Fire Safety Engineering Design Review for DA Submission

5 Skyline Crescent, Horningsea Park NSW 2171 (Lot 1, DP 1266533)

Date: 6 April 2022
Document ref: 297222
Issue No: 2.0
Author: Parkan Behayeddin

Figure 2.2: Site Plan

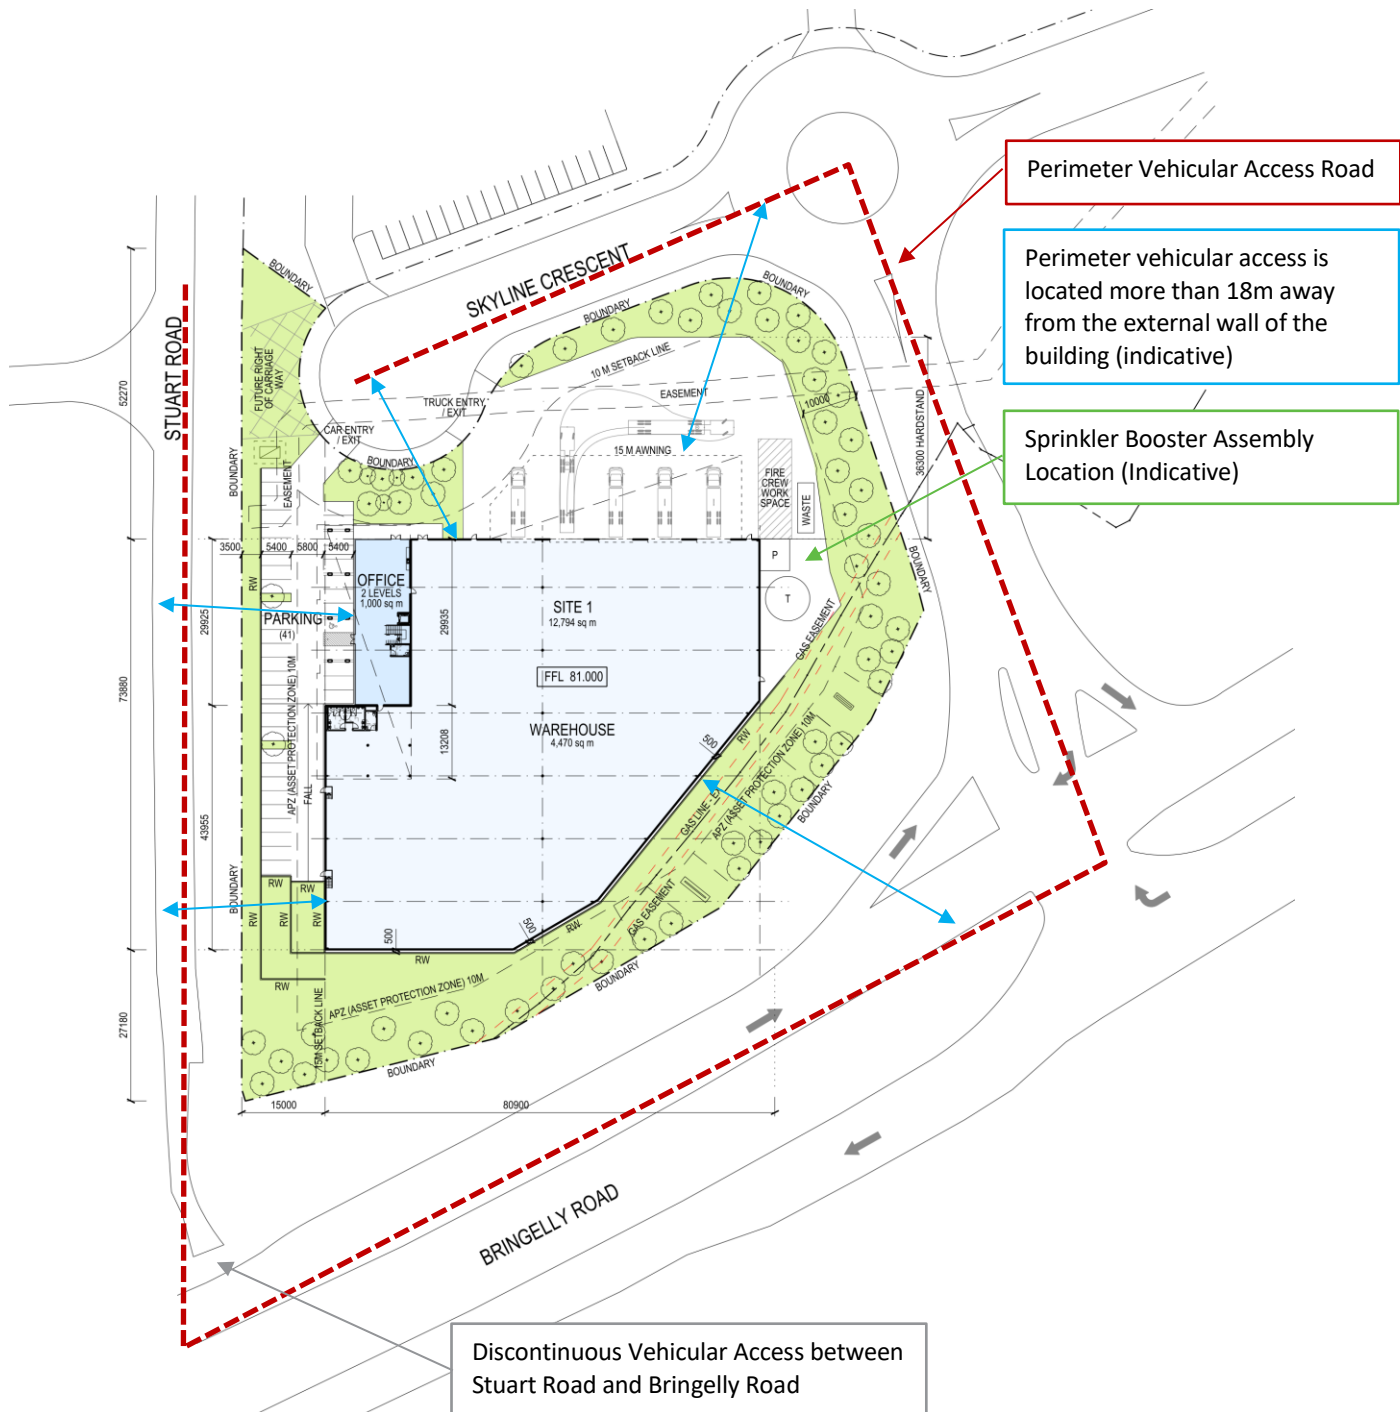
The preliminary review of the design has identified that the proposed location of the sprinkler booster assembly is technically not at the site boundary, not at the principal entry location and not within direct line of sight of the main entrance to the building. The methodology to be adopted to address the design issue relative to the location of the sprinkler booster assembly shall be based upon a qualitative evaluation. The evaluation shall give consideration to the potential risks associated with the proposed sprinkler booster assembly location and the proposed fire safety measures which shall assist attending Fire Brigade personnel in locating the respective booster assemblies. The identified measures shall include block plans, additional signage denoting the sprinkler booster location on site, the adoption of a red strobe light to clear denote to attending fire brigade personnel the location of the sprinkler booster and also to ensure that the booster is accessible to accommodate fire brigade operations. The preliminary assessment undertaken by Scientific Fire Services suggests that the identified design issue for the sprinkler booster can satisfy the relevant *Performance Requirements*, namely EP1.4 of the BCA.
